May 29, 2015

ADDENDUM NO. 2

TO PROSPECTIVE BIDDERS UNDER RFQ NO. 1512, "CAMANCHE RECREATION
AREA ULTRAFILTRATION MEMBRANE SKIDS"

Design By: BS	East Bay MUD
Drawn By: BS	Camanche South Shore
Date:	Water Treatment Plant
Scale:	Floor Plan
C-005	Rev. 0

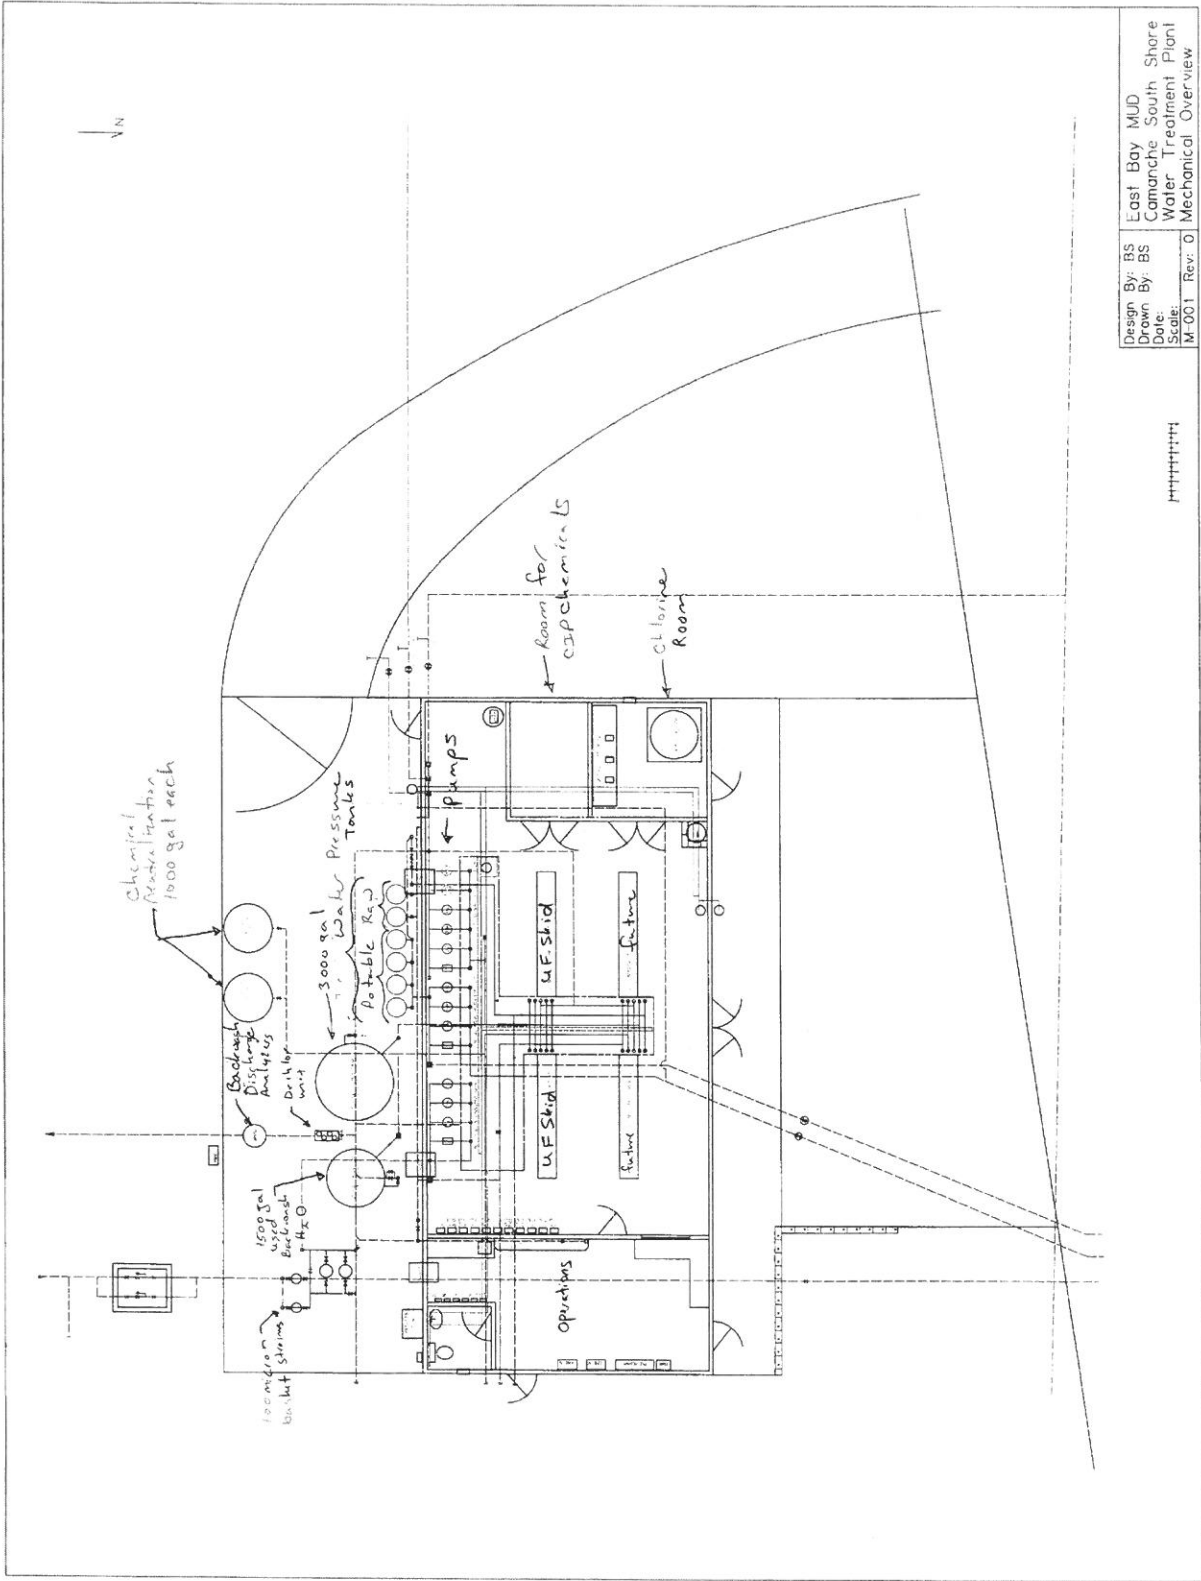
- a. Are pictures or a floor plan drawing available that shows the UF process area (16'x20'x8.5') and CIP area (8'x10'x8.5') with the 6'x6' 8" door locations and other infrastructure locations (feed & backwash pumps, feed & backwash supply surge tanks, effluent clearwell, backwash waste tank, chemical tanks, etc.)?

See drawings included in this addendum as Exhibit G.
